Ref: SSD-82709458

RE: SUBMISSION TO SSD-82709458 FOR RESIDENTIAL DEVELOPMENT WITH IN-FILL AFFORDABLE HOUSING AT 21, 23 & 25 MCINTOSH STREET AND 55 WERONA AVENUE, GORDON

Ku-ring-gai Council's objection to SSD-82709458 at Nos. 21, 23 & 25 McIntosh Street and No. 55 Werona Avenue, Gordon

Figure 1: Maximum building height and FSR under Council's Plan

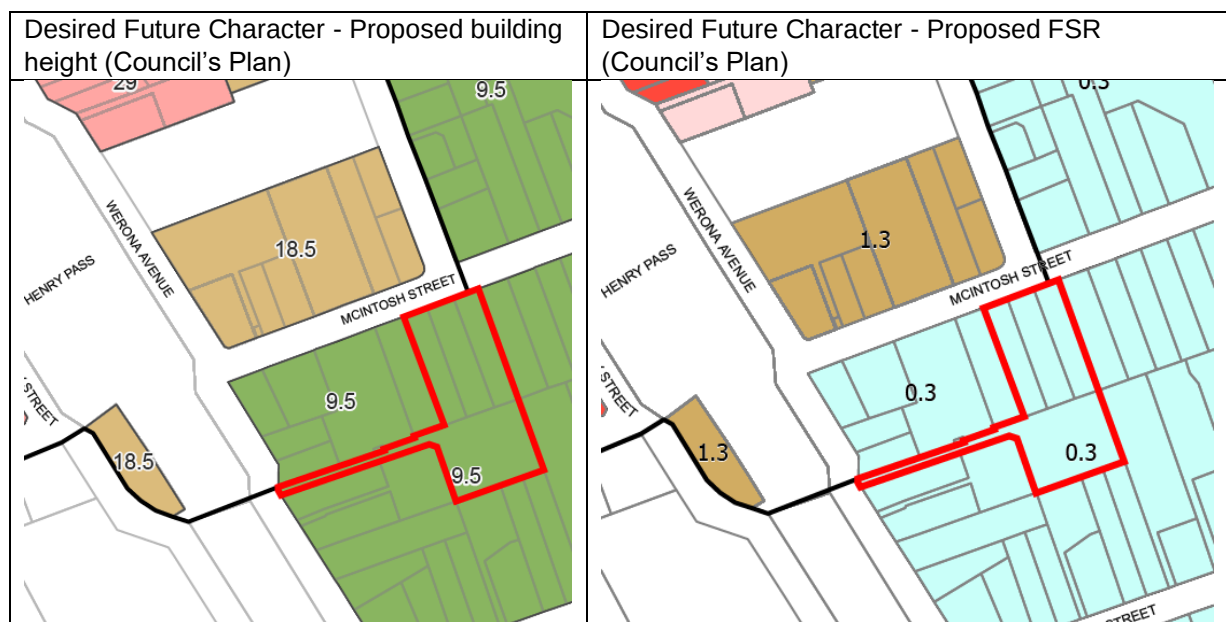
Figure 1 shows the location of the proposed development (red outline) in relation to maximum building height and floor space ratio under Council's Plan.

In light of Council's Plan, the proposed building height and FSR are excessive and result in a significantly taller and bulkier building which is out of character with the desired future character of the area.

Fig 9. And 10. SSDA Design Report by PMDL July 2025 street elevation-view from Stanhope Road, Killara

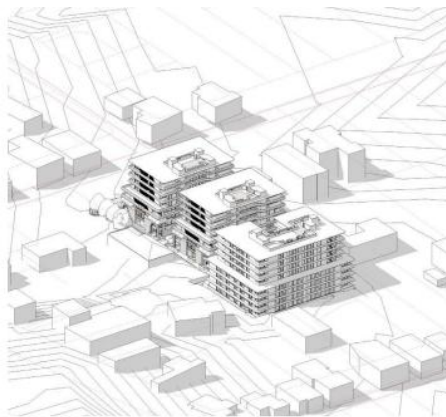
Views from these heritage items will drastically change from low rise to high rise with loss of trees as they will be obscured by three large scaled 8 storey buildings.

Figure 10: Recommended location for visitor parking (red area)

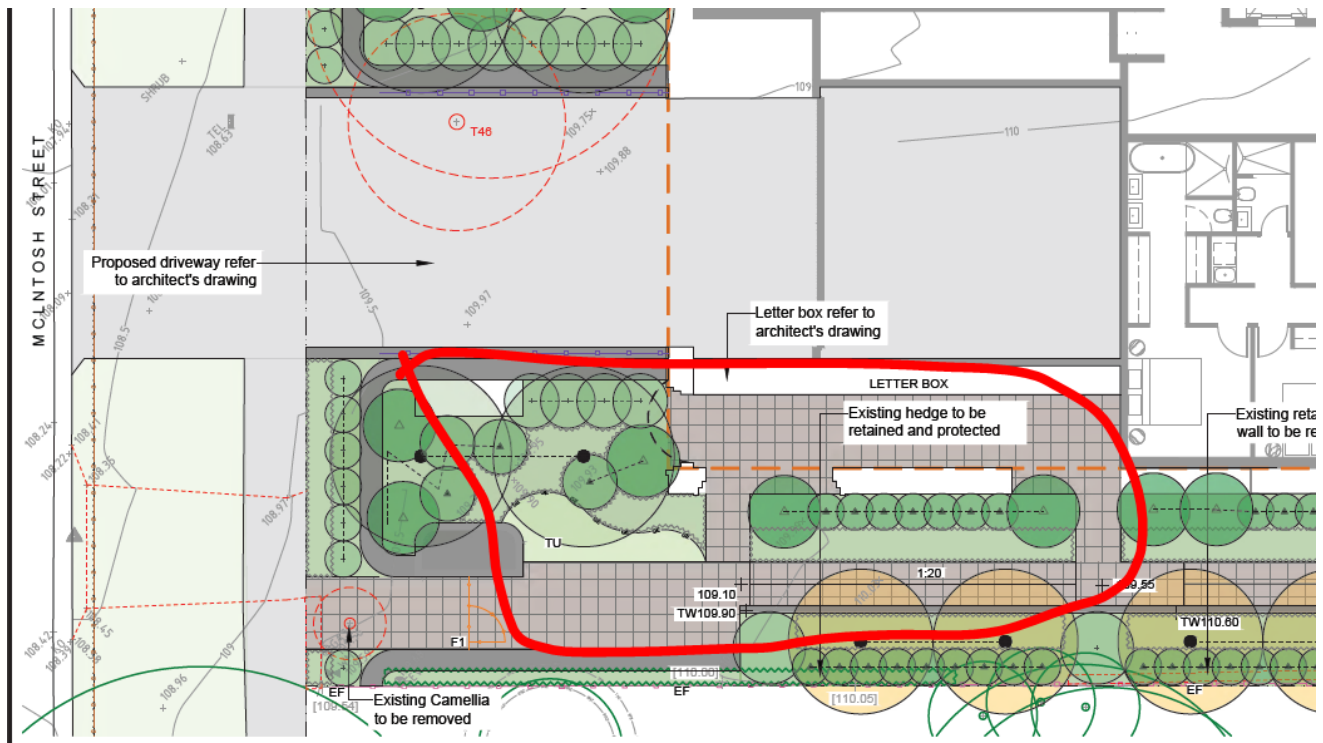
According to the TIA, visitor bicycle parking is proposed to be located on the Basement 1 level, but the parking facilities could not be found on the architectural plans and it is unclear whether visitor bicycle parking is intended to be located in the Bicycle Storage rooms on Basement 1 level. This needs to be clarified. Regardless, similar ramp gradient issues as residents arise (as noted above), and given the additional practicality of visitors entering the secure parking area to access the bicycle parking from the main entry ramp, it is recommended that the visitor bicycle parking be relocated to somewhere behind the gate from the McIntosh Street pedestrian entrance, marked-up in red on the General Arrangement Sheet 1 landscape plan:

The pedestrian ramp at the Werona Avenue entrance should be sized to allow people to dismount and wheel their bicycles between street level and the internal courtyard/entry areas. It is also noted that there are multiple gates shown along the Werona Avenue pedestrian access route as part of the landscape plans. The CPTED report indicates a gated entry near the Werona Avenue frontage but it is not shown on the landscape plans or the architectural plans. With multiple gates along this access way, pedestrian access to the development from Werona Avenue needs to be clarified.
